SUBJECT: BOARD OF CURATORS OF THE UNIVERSITY OF MISSOURI – ISSUANCE
OF AMENDMENT NO. 23 TO RENEWED FACILITY OPERATING LICENSE
NO. R-79 FOR THE MISSOURI UNIVERSITY OF SCIENCE AND
TECHNOLOGY RESEARCH REACTOR TO CHANGE ADMINISTRATIVE
CONTROLS IN THE TECHNICAL SPECIFICATIONS TO REFLECT
REORGANIZATION OF THE DEPARTMENT OF NUCLEAR ENGINEERING
AND RADIATION SCIENCE (EPID NO. L-2020-NFA-0014)

AMENDMENT TO RENEWED FACILITY OPERATING LICENSE

SAFETY EVALUATION BY THE OFFICE OF NUCLEAR REACTOR REGULATION

Figure 6.1 Organizational structure of the University of Missouri related to the Missouri S&T Nuclear Reactor Facility

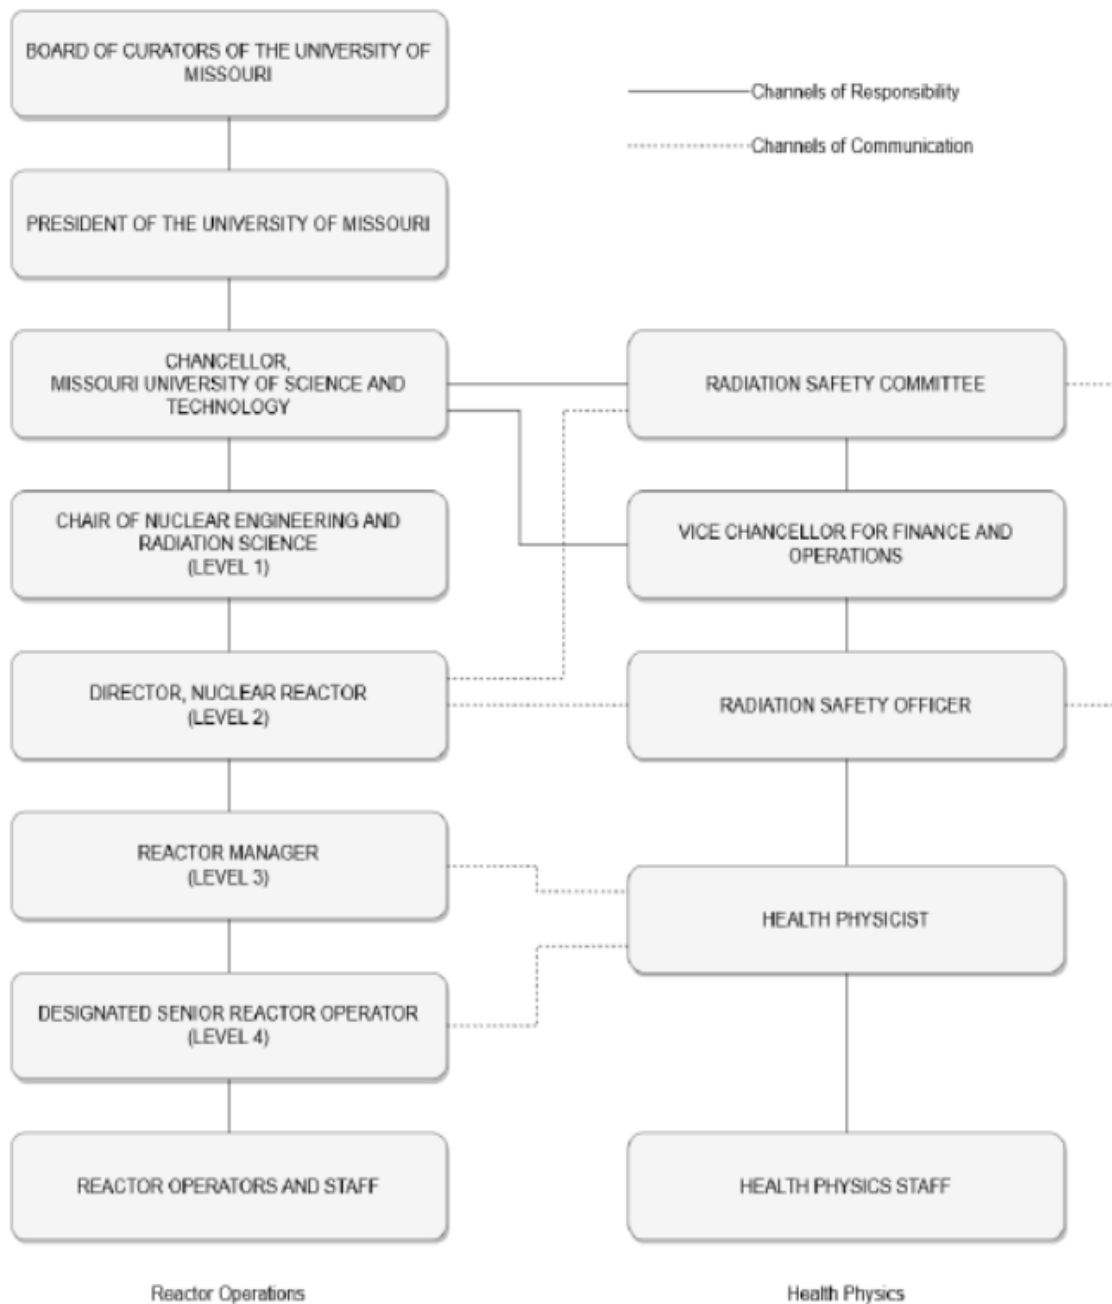
The U.S. Nuclear Regulatory Commission (NRC) has issued the enclosed Amendment No. 23 to Renewed Facility Operating License No. R-79 for the Missouri University of Science and Technology Research Reactor. The amendment modifies technical specification (TS) 6.1, "Organization," in response to the application dated December 2, 2020 (Agencywide Documents Access and Management System Accession No. ML20337A162). Specifically, the amendment revises TS 6.1.1, "Structure," to include the new department name of the Department of Nuclear Engineering and Radiation Science and changes the title for the Level 1 person specified in TS 6.1.2, "Responsibility." The amendment also changes TS Figure 6.1, "Organizational Structure of the University of Missouri related to the Missouri S&T Nuclear Reactor Facility," to reflect the department name change from "Administrative Services" to "Finance and Operations." Additionally, the amendment makes minor format and punctuation changes in TS Figure 6.1.

Figure 6.1 Organizational structure of the University of Missouri related to the Missouri S&T Nuclear Reactor Facility

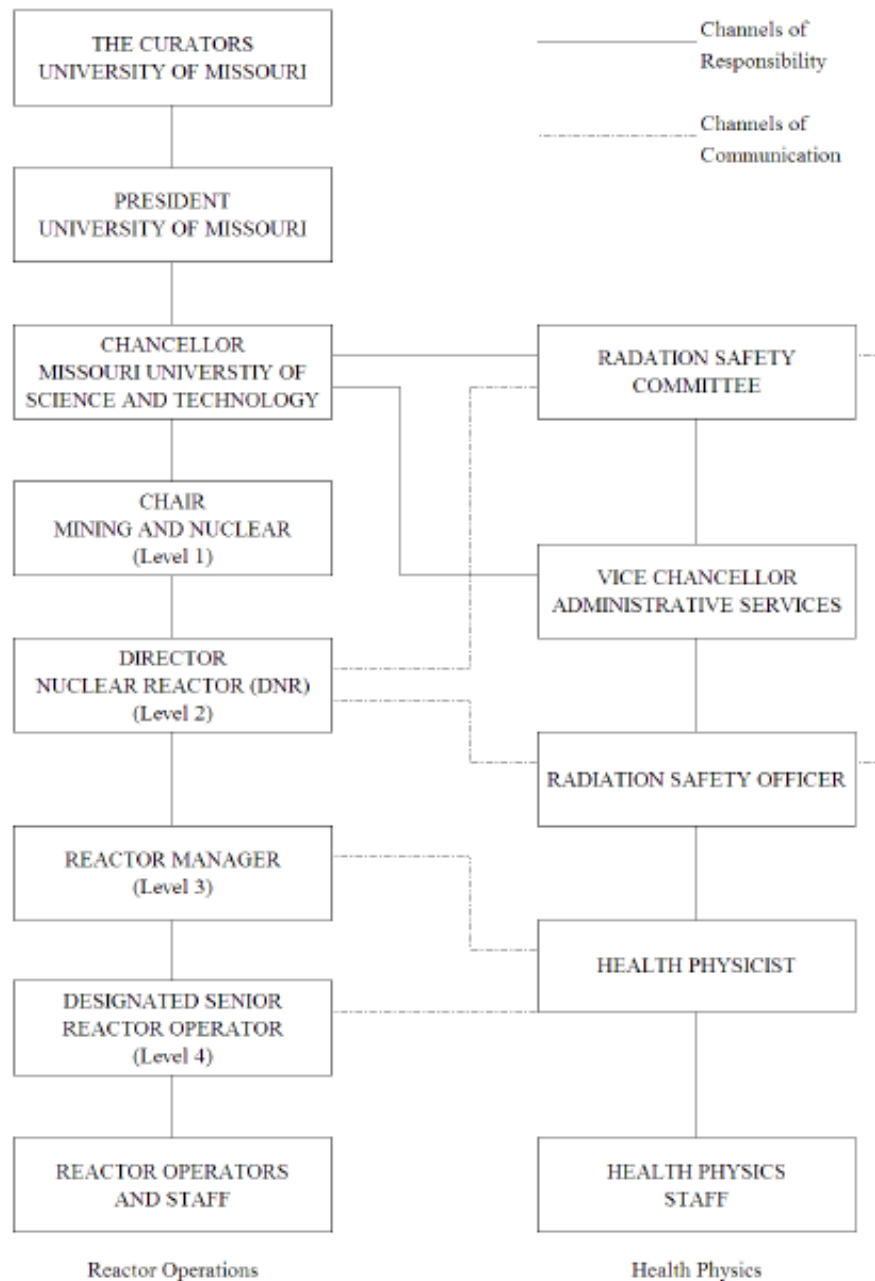
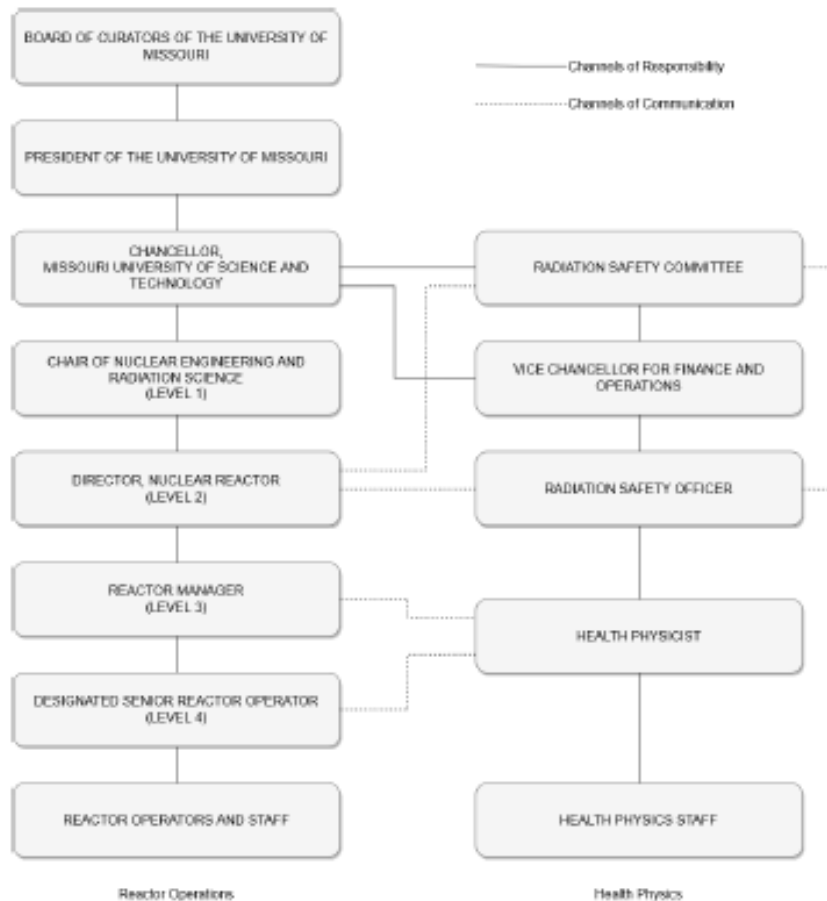
The licensee proposed several changes to TS Figure 6.1 to reflect the new names in the organizational structure:

- Change the name of the licensee from “The Curators University of Missouri” to “Board of Curators of the University of Missouri” to be consistent with the name of the licensee in Section I.A. of Renewed Facility Operating License No. R-79 and as specified in the definition of “licensee” in TS 1.2, “Definitions.”
- Change the name of the Level 1 administrator from “Chair Mining and Nuclear” to “Chair of Nuclear Engineering and Radiation Science.”
- Delete “Vice Chancellor Administration Services” and replace it with “Vice Chancellor for Finance and Operations.”
- Delete “(DNR)” from the Level 2 administrator’s title of “Director Nuclear Reactor.”

The NRC staff evaluated the proposed changes using the guidance in ANSI/ANS-15.1-2007, Section 6.1, which states that the functions, assignments, and responsibilities shall be specified in the TSs. The NRC staff finds that the proposed updated organizational names do not alter the responsibilities and structure of the operating organization. The NRC staff also finds that the proposed changes to TS Figure 6.1 are to the positions or titles of officers or organizational

units of the licensee and are consistent with ANSI/ANS-15.1-2007, Section 6, in that the TSs continue to specify the required licensee organizational structure and management responsible for reactor facility operations. Therefore, the NRC staff concludes that changing the above organizational names in TS Figure 6.1 is acceptable.
